EASTGATE COMMERCIAL PARK, PHASE II

FINAL DEVELOPMENT PLAN

Re: Project 611-659 Eastgate Commercial Park, Phase II – Final Development Plan

RE: Project 611-659 Eastgate Pkwy Final Development Plan

A LANDSCAPE PLAN
SCALE: 1"=40'-0"

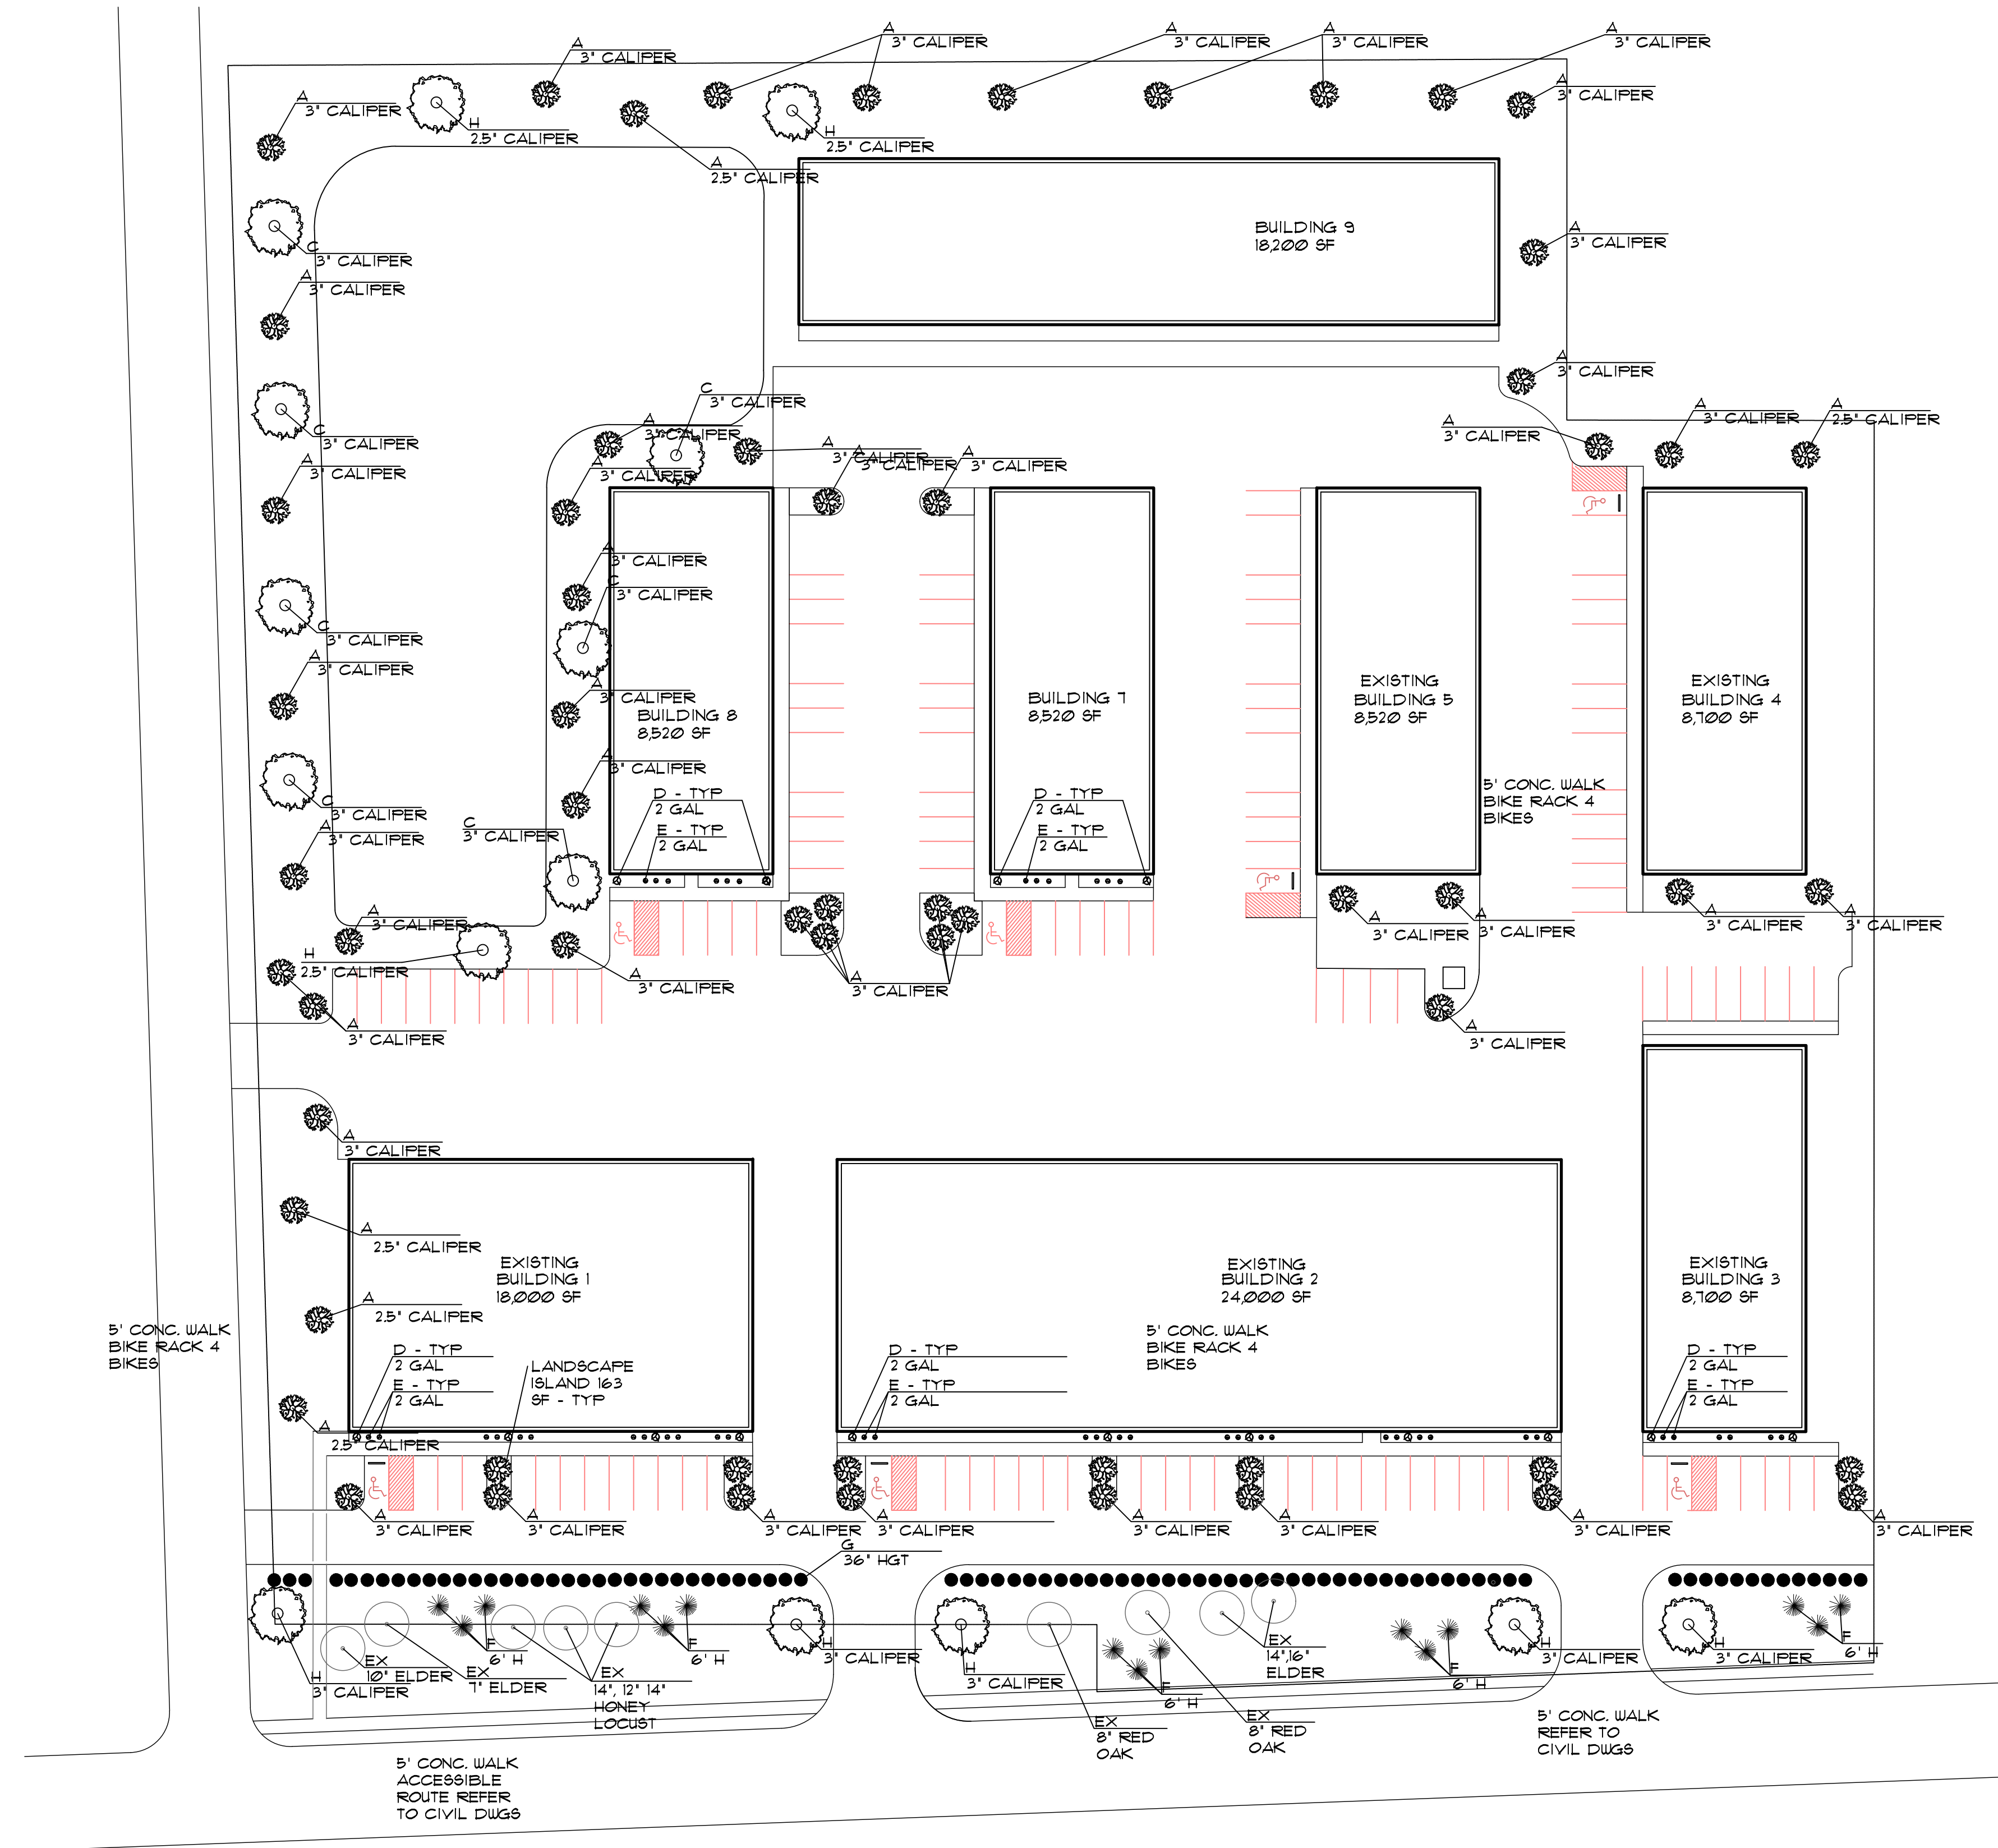
7. It appears that the landscaped areas are not included on this submittal as they were for the previously approved plan. Please include the interior parking lot landscaping requirements per Section 1163.08. Included calculations for minimum amount of landscaping area and minimum number of trees.
Landscaping sheet has been added to the plan.

9. Chapter 914 requires one tree inch to be planted per 1,000 square feet of impervious surface. This requirement is in addition to any other planting requirements.
Landscaping sheet has been added to the plan.

5. It appears that the landscaped areas are not included on this submittal as they were for the previously approved plan. Please include the interior parking lot landscaping requirements per Section 1163.08. Included calculations for minimum amount of landscaping area and minimum number of trees. The submitted landscaping plan shows the previously approved building layout - not the proposed layout with the large 18,200sqft building. Update the plan to reflect the new layout. *Updated Accordingly.*

7. Chapter 914 requires one tree inch to be planted per 1,000 square feet of impervious surface. This requirement is in addition to any other planting requirements. The submitted landscaping plan shows the previously approved building layout - not the proposed layout with the large 18,200sqft building. Update the plan to reflect the new layout.

10. I would like to see planting specifications included in the landscape plan. Also, I would like to know what species of maple is intended for planting. *The Landscaping Plan has been revised accordingly.*

6. Tree planting specifications are not entirely appropriate. Pruning should only take place at planting if branches are broken or damaged. Corrective pruning and clearance pruning should be delayed until a full season of growth. At least the top 1/3 of the burlap should be cut away. Root flare should be planted even with finished grade. Trees should not intentionally be planted 2" above nursery height. Mulch should be pulled away completely from trunk. **Landscaping plans have been updated accordingly.**

Prunus cerasifera 'Newport' and Malus spp. are both very susceptible to a variety of pests and diseases. Alternative species should be considered to replace these trees. Maple species is still not identified on the landscape plan. The maple family is large, and the species in the family range on size and a number of other features. **Landscaping plans have been updated accordingly.**

214,633 SF IMPERVIOUS SURFACE EXISTING
 57,353 SF PROPOSED ADDITIONAL PAVING =
 271,986 SF
 /1000 = 272 CAL INCHES OF SUPPLEMENTAL PLANTINGS (57 ADDITIONAL INCHES)

Previously Approved Plan:

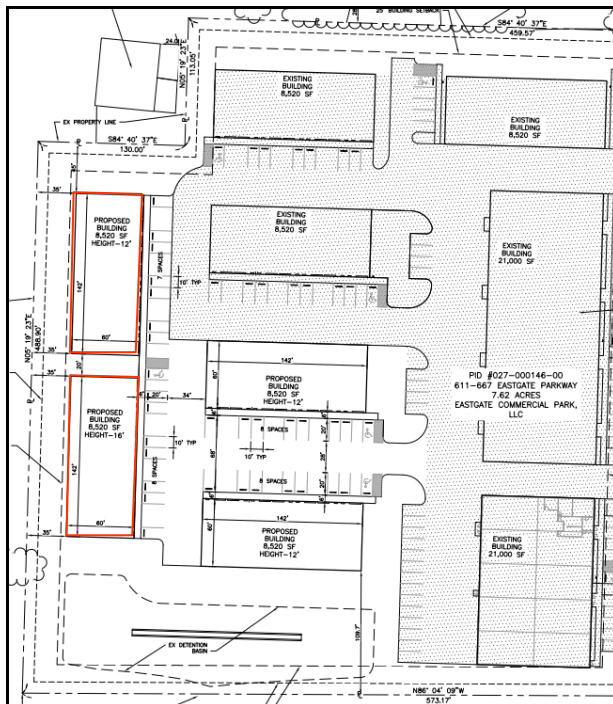
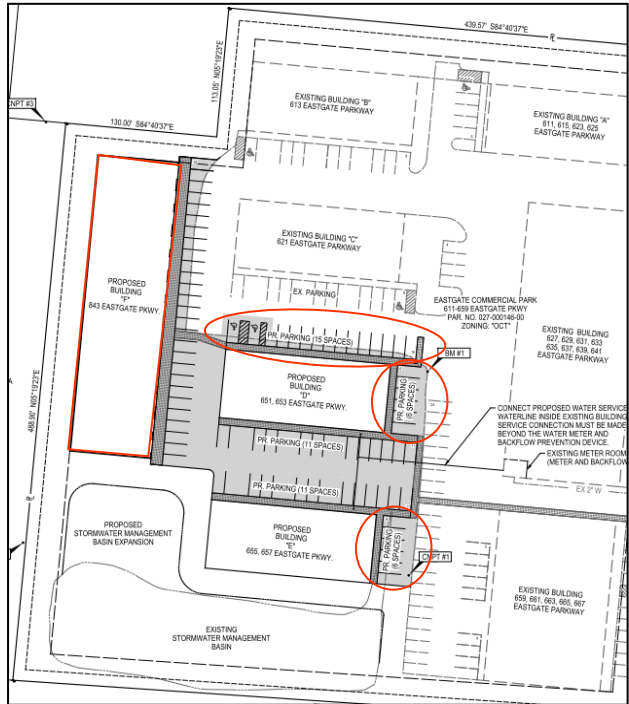
- Replacing two 8,500sqft buildings at the rear of the property with one large 18,200sqft building.
- Rear buildings were approved at 35ft from the rear property line and 45ft from the side (north) property line whereas the new building will be 30ft from the rear property line and 25ft from side property line.
- The addition and revised layout of parking spaces from the approved 31 spaces to the proposed 63 spaces.
